APPROVED MINUTES

November 16, 2012 Standards Committee Meeting
(Changes to the Final Draft on page 12, part 2 highlighted yellow.)

RE: Minutes from the November 16, 2012 Standards Committee Meeting

Picture 1

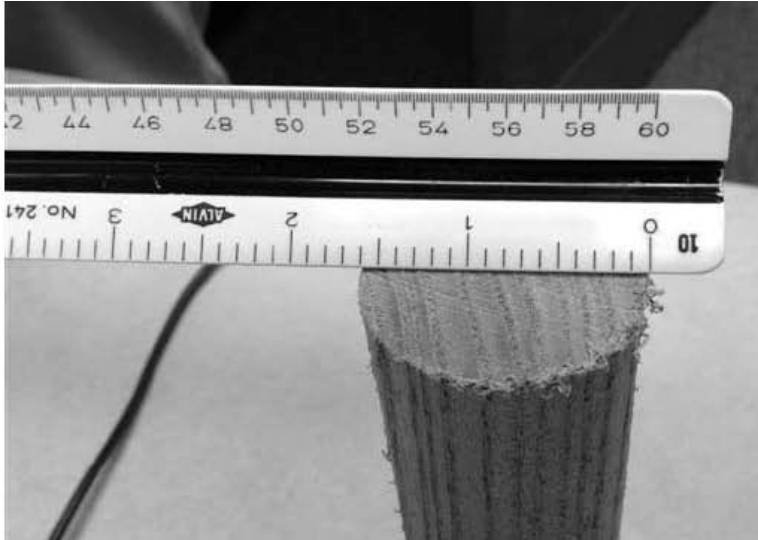
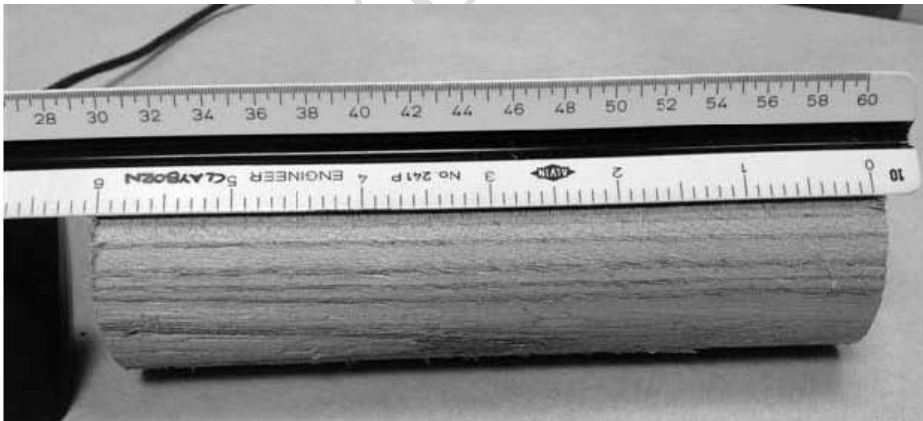
PROBLEM(S) ENCOUNTERED: To date, I have heard of underseal material migrating upwards on three active contracts to include the US-40 project west of Greenfield. Standard Specification section 612 states:

This should be the end of the story but as of recent it has not been. We know the undersealing operations have/are occurring before milling operations. We know the historical material used has been UA-III but recent projects have been using UA-II (less viscous) due to supply issues with UA-III. The UA-II material can be 4 times more ductile and approximately 1.5 times softer at higher temperatures than the UA-III. Tommy Nantung's assessment that UA-II is the wrong material for use in undersealing operations is probably correct but should be irrelevant assuming the drilled holes were properly sealed. Some drilled holes are being properly sealed as evidenced by only a percentage of them displaying visual evidence of actually leaking. I believe milling the pavement after the drilled holes are plugged is the primary cause for the observed problem; the secondary cause is the UA-II material. Hypothesis: the wooden plugs are damaged to an extent they no longer afford a reliable seal to prevent the UA-II material from migrating upwards; the underseal material lacks the physical qualities to resist the upward migration.

The current specification in 612 does not account for the milling operation.

PROPOSED SOLUTION: Require an inspection of all wood plugs upon completion of milling and before overlaying with HMA pavement. Damaged or loose plugs should be replaced.

BACKUP 02 EXISTING DRAWING 720-MHCA-02 MANHOLE CASTING TYPE 4 RING AND COVER

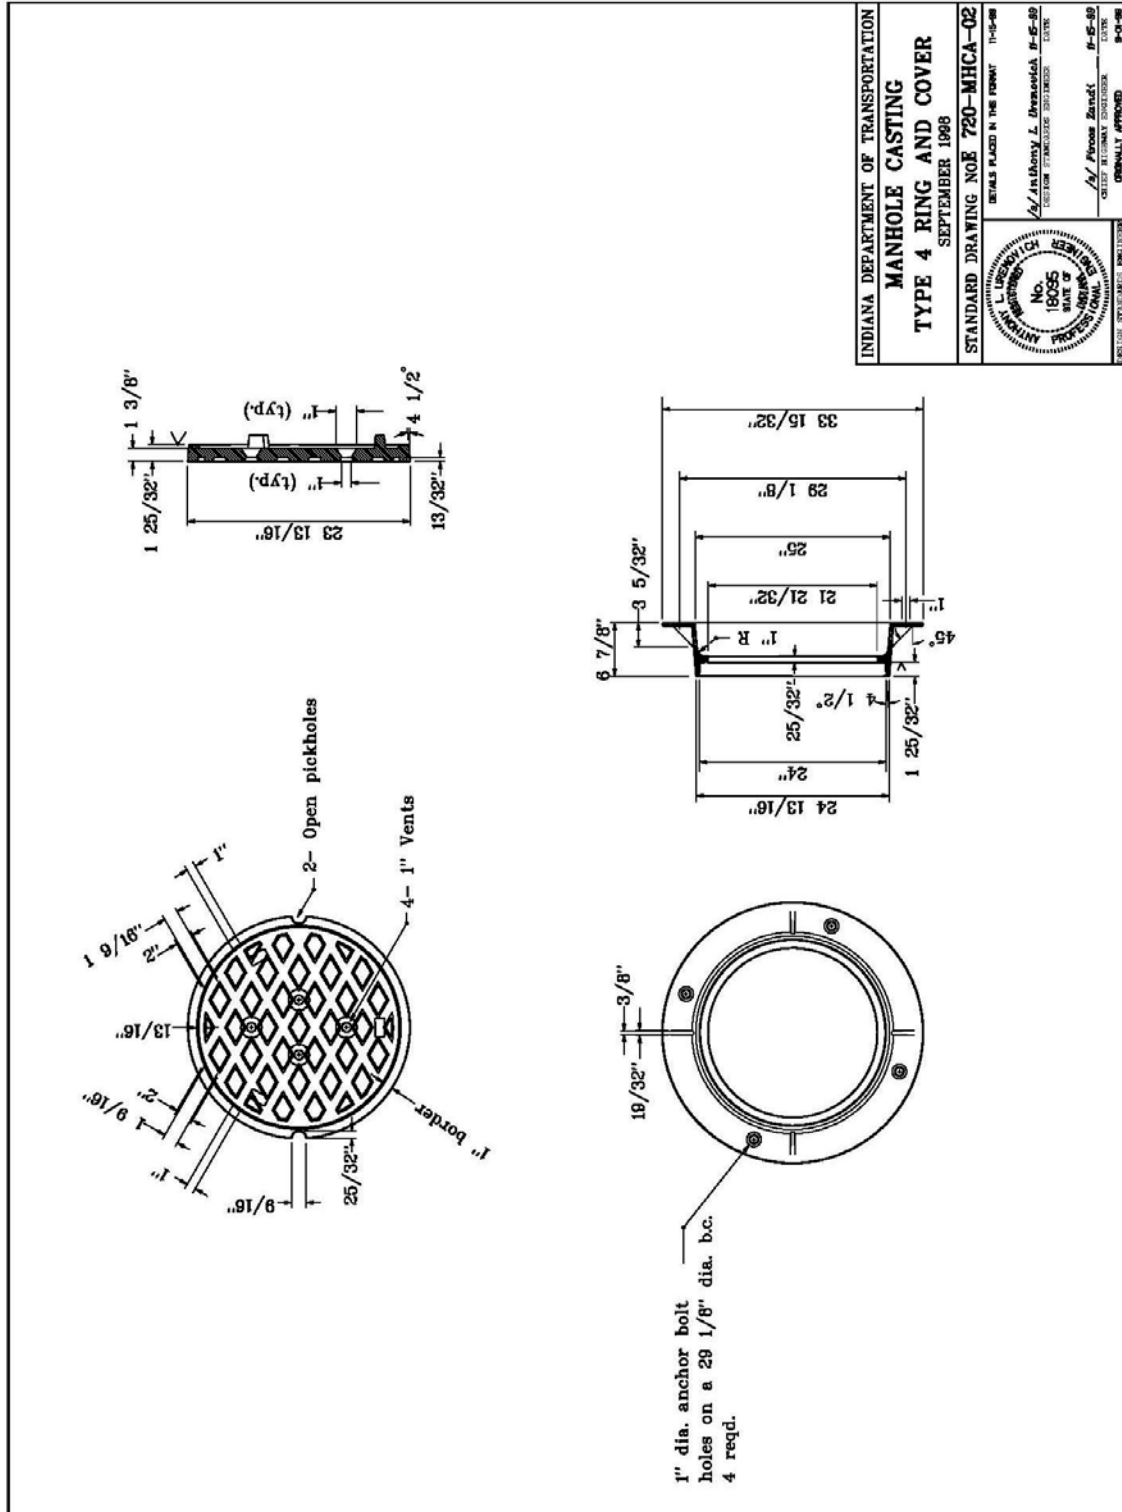
DISCUSSION: Presented by Ms. Phillips as described on the proposal page. Mr. Keefer mentioned that the lids with the smaller openings are also of a smaller diameter, so would not be interchangeable with the lids in question. Mr. Miller asked if this could be resolved by a design memo. Mr. Keefer suggested it be a separate item for ADA/sidewalk applications. Mr. Vancleave agreed. Ms. Phillips asked if a supplemental description would be enough.

John Crist of East Jordan Iron Works suggested modifying their Type 4 cover to fit this application. Also the diamond pattern on the Type 4 is quite aggressive. Mr. Crist suggested a different frame set altogether that has smaller vent hole and the diamond pattern is less aggressive.

PROBLEM(S) ENCOUNTERED: With the ADA regulations it is recommended that castings not be placed in an area that pedestrians can walk. Many times a casting cannot be relocated to outside of this area. The castings used within a sidewalk or pedestrian area are typically a flat top lid. The current INDOT standards for a flat casting on a manhole is meant for placing this only in a pavement area and is not conducive to a pedestrian environment. A flat casting is needed that can also be placed within an area that pedestrians navigate. The current INDOT design guideline states the following:

Gratings should not be placed within the walking surface. If, however, gratings are located in the walking surface, they should have openings of not greater than 1/2 in. in one direction. If gratings have elongated openings, they should be placed so that the long dimension is perpendicular to the dominant direction of travel.

The suggestion by Mr. Miller is to create a separate pay item for this specific application. Ms. Phillips will work on that.

PROPOSED SOLUTION: Provide a casting detail for use within a sidewalk that does not violate the opening greater than 1/2". This standard would be added to the other standard castings and be identified to use within a sidewalk or pedestrian area.

CONCEPTUAL PROPOSAL 2
BACKUP 03 EXISTING DRAWING 720-MHCA-03 MANHOLE CASTING TYPE 4 ALTERNATE COVER

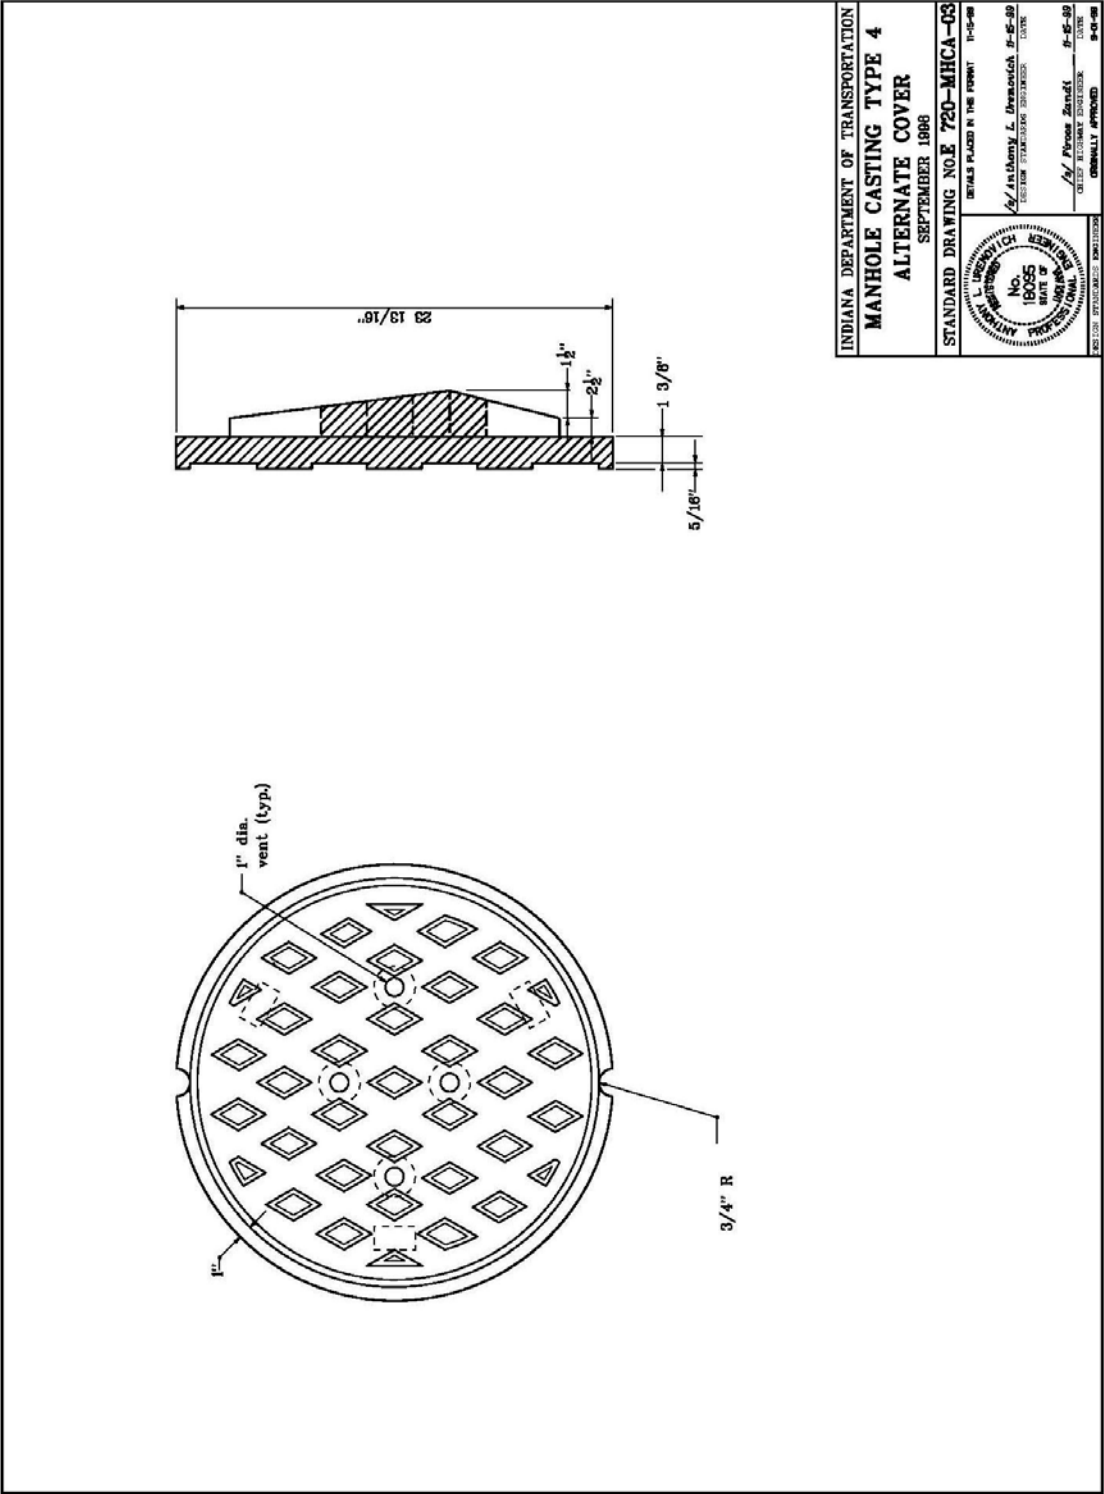
APPLICABLE STANDARD DRAWINGS: This would require a new standard drawing or add to the current E-720 MHCA-03 detail.
